ADDRESS . . : 96 ROBERT BRANCH CIR SUBDIV: MILL BRANCH
 CONTRACTOR : R & K ANDERSON BUILDERS INC PHONE : (910) 893-1012
 OWNER . . : R & K DEVELOPING LLC & ANDERSON PHONE :
 PARCEL . . : 08-0652- - -0097- -22-
 APPL NUMBER: 07-50018766 CP NEW RESIDENTIAL (SFD)
 DIRECTIONS : MILL BRANCH SUB DIV LOT #22 HWY 401 N
 OF LILLINGTON 2 MILES, SUB DIV ON
 RIGHT, IN MILL BRANCH CIRCLE, LEFT ON
 ROBERT BRANCH CIRLE, LOT ON RIGHT (22).
 T/S: 10/30/2007 08:57 AM VBROWN ----

HARNETT COUNTY
Building Inspections Dept.

ENGINEERS REPORT:

PORCH SUPPORT
REVISION

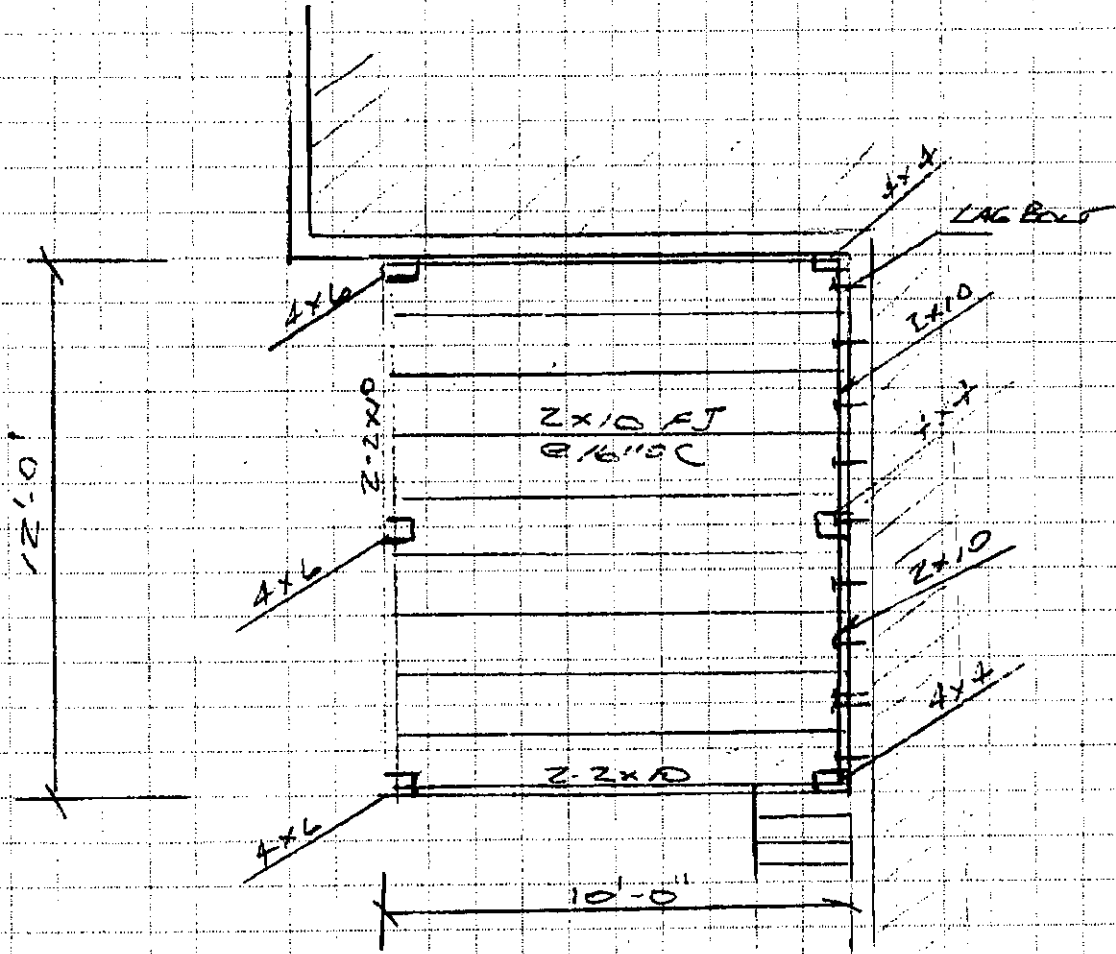
1. Bolts on porch band must be 5/8" galv. And all the way through the foundation with a nut
2. Handrail needed on front steps
3. Outlet needed on little counter area (by refrig.) when greater than 12"

I129 01	3/04/08 4/03/08	BS AP	R*INSULATION INSPECTION VRU #: 001571793 This inspection was actually schedule for 4/4/08, but the wrong date was punch in. It was approved on 4/4/08
R427 03	4/04/08 4/04/08	BS AP	FOUR TRADE ROUGH IN >2500 VRU #: 001588177 1. Rough in and insulation approved, however, deck must be bolted to house before final. When using a single rim to support floor joists, you cannot support it on posts, it must be bolted
H824 01	4/11/08 4/11/08	OT AP	✓ ENVIR. OPERATIONS PERMIT TIME: 17:00 VRU #: 001594191
R431 01	8/18/10 8/18/10	MR DP	FOUR TRADE FINAL >2500 VRU #: 001971175 T/S: 08/18/2010 02:25 PM MREARIC ----- 1. porch must be through bolkted to foundation with 5/8" galv. bolts with nuts

1. THE FLOOR SYSTEM CONSISTS OF 2X10
AT 16" OC. THE OUTSIDE DOUBLE END
IS SUPPORTED BY 3- 4X6 POST WITH CONC.
FOOTINGS. THE INTERIOR 2X10 BAND IS
SUPPORTED BY 3 4X4 POST WHICH BEAR
ON THE CONC FOOTINGS OF THE EXTERIOR WALL.
THE 2X10 BAND IS ATTACHED TO THE
SABASE WALL WITH 5/8" LAL BOLTS. THE MASONRY
FOUNDATION WALL IS BELOW THE BAND ATTACHMENT LINE.
THE LOAD ON THE 2X10 BAND IS 250[#]/LF. THE
2X10 IS CAPABLE OF SUPPORTING 396[#]/LF AND
IS ADEQUATE FOR THE ACTUAL N.C. BUILDING CODE REQ. LOAD.

SUMMARY: THE 10 LAL BOLTS PROVIDE LATERAL SUPPORT.

THE 2X10 BAND IS ADEQUATE TO SUPPORT THE FLOOR LOADS
AS CONSTRUCTED.
